City of Portland, Maine – Building or Use Permit Application 389 Congress Street, 04101, Tel: (207) 874-8703, FAX: 874-8716

| Location of Construction: 115 Caleb St | | Owner: Chin, Toeur | | Phone: | | Permit No: 980309 | |
| Proposed Project Description: Construct Addition (12 x 14) ← Construct Deck (14 x 10) | | | | Signature: | | Signature: [Signature] | |

BUILDING PERMIT REPORT

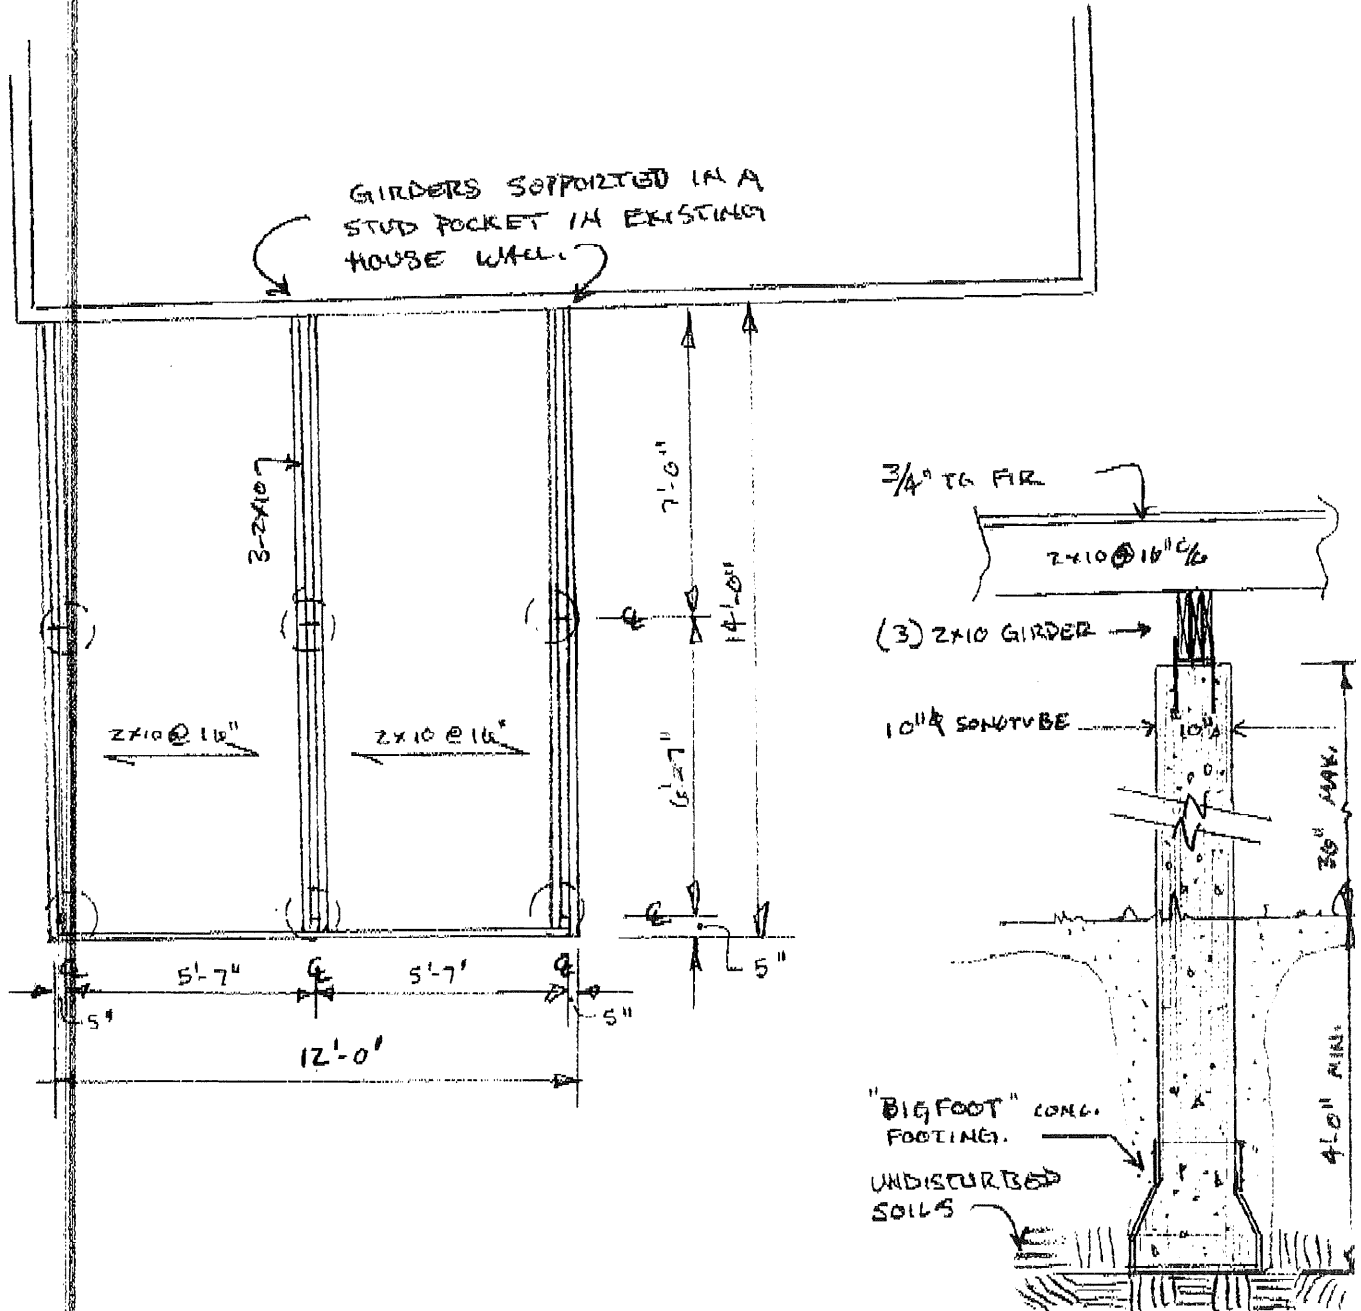
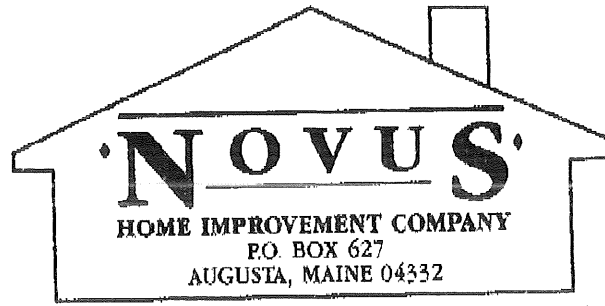
X 29. The proposed addition must be constructed on a minimum of a 8" Frost wall or engineered slab - NO WORK IS TO BE STARTED UNTIL A NEW FOUNDATION PLAN HAS BEEN SUBMITTED AND APPROVED BY THIS OFFICE -

THIS IS A PLAN & SECTION OF THE 10" CONCRETE
AND THEIR LOCATION. THIS SHOULD BE AN ADDENDUM
TO THE FIRST PLANS.
